The purpose of this summary is to technically respond to the water stakeholder comments received by Park City Municipal Corporation (PCMC) on the constructed wetland proposal which was presented to the Silver Creek Stakeholder Group by Dr. Fitch on January 13th 2006.

During the month of February, PCMC received comments from the Bureau of Land Management (BLM), U.S. Fish and Wildlife Service (FWS), as well as David Reisman, Dan Wall, and Brian Caruso all representing the United States Environmental Protection Agency (USEPA). The format of this correspondence is divided by each respondent and will address the comments expressed by the stakeholders. Dr. Fitch's response to the respondents has been included in this document and the question will be identified as a bullet and his response denoted as "UMR".

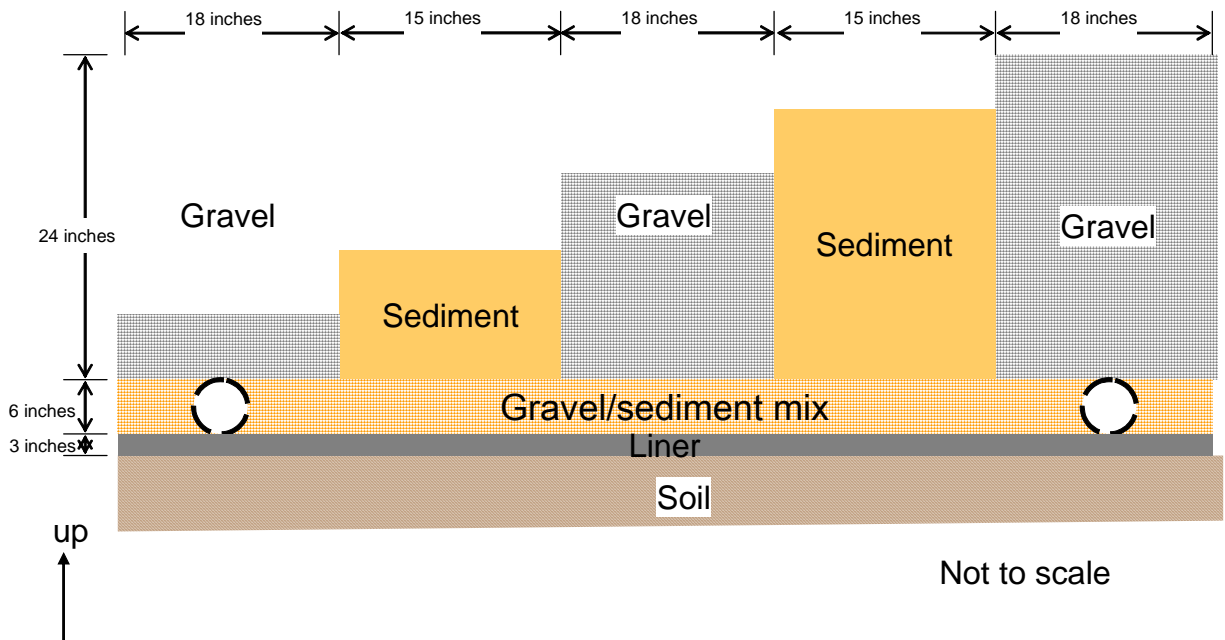
- Feasibility in terms of construction and operation & maintenance, with specific questions about how the alternating layers of gravel and active biological "substrate" will be laid down.

The suggested construction method is to lay down a short lift, 4-6 inches deep, illustrated below. During construction, the various levels will be ziggurat-like, and strings can mark the edges of each lift/layer. A skid loader or small dozer (something with a 5-6 foot reach with a bucket) can pour the material (gravel or mixed substrate) onto the layer followed by manual dress up to roughly level that layer. The individual lifts will slump only a small amount because the exposed height is only a few inches.
